# Access Compliance Report

## Public Rights-of-Way

Intersection ID: 47974	Main Street: TOM_SHORT_RD	Cross Street: BRYANT_FARMS_RD	Location: NW
ADA ID: 5424010F46B5	Ramp Type: Perp	Initial Pass/Fail: Fail	Overall Compliance: No
			Severity Score: 21.25

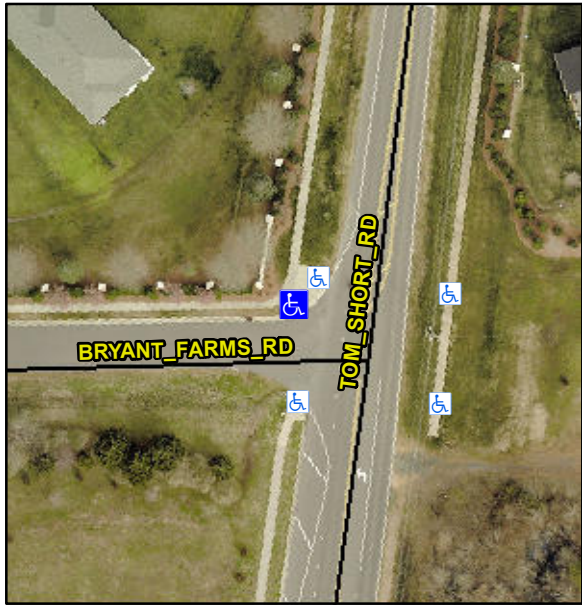
Codes/Mitigation Info/Possible Solution			Field Measurements/Component Compliance					
	Possible Solutions:		Compliance	Description	Data	Compliance	Description	Data
	Remove & Replace Entire Ramp.		N/A	Ramp Length (in)	94.0	No	Ramp Slope (%)	9.4
			No	Ramp Width (in)	46.0	Yes	Ramp XSlope (%)	1.9
			N/A	Flare Type LT	N/A	N/A	Flare Type RT	N/A
			N/A	Flare Slope LT (%)	N/A	N/A	Flare Slope RT (%)	N/A
			N/A	Flare Traversable LT?	N/A	N/A	Flare Traversable RT?	N/A
			N/A	Landing Length (in)	N/A	N/A	DWS Provided?	N/A
			N/A	Landing Width (in)	N/A	N/A	DWS Contrast?	N/A
			N/A	Landing Slope (%)	N/A	N/A	DWS Length (in)	N/A
			N/A	Landing X Slope (%)	N/A	N/A	DWS Full Width?	N/A
<p>Surveyor Notes:</p> <p>N/A</p> <p>PROW/ADA:</p> <p>Not Found, R304.5.1, R304.2.2</p>			N/A	Landing Curb? (Y/N)	N/A	N/A	DWS Offset (in)	N/A
			N/A	Shared Landing?	N/A			
			N/A	Gutter Ponding?	N/A	N/A	Gutter Slope (%)	N/A
			N/A	Gutter Lip Ht (in)	N/A	N/A	Gutter X Slope (%)	N/A

N/A	Painted X Walk1?	No	N/A	Painted X Walk2?	N/A
				X Walk 1 Direction	To S		X Walk 2 Direction	N/A
			N/A	X Walk 1 Width (in)	N/A	N/A	X Walk 2 Width (in)	N/A
				X Walk 1 Slope (%)	1.6		X Walk 2 Slope (%)	N/A
				X Walk 1 X Slope (%)	2.6		X Walk 2 X Slope (%)	N/A
			N/A	Ramp inside XWalk1?	N/A	N/A	Ramp inside XWalk2?	N/A
<p>Total Cost:</p> <p>\$ 1850.00</p>				Road Slope (%)	N/A	N/A	Clear Space?	N/A
				Road X Slope (%)	N/A	N/A	Clear Space to XWalk (in)	N/A
			N/A	Any Obstructions?	N/A	N/A	Storm Grate/Utility Hazard?	N/A
				Obstruction Type			Storm Grate/Utility Type	
					N/A			N/A
						Yes	Surface Condition? (G/P)	Good
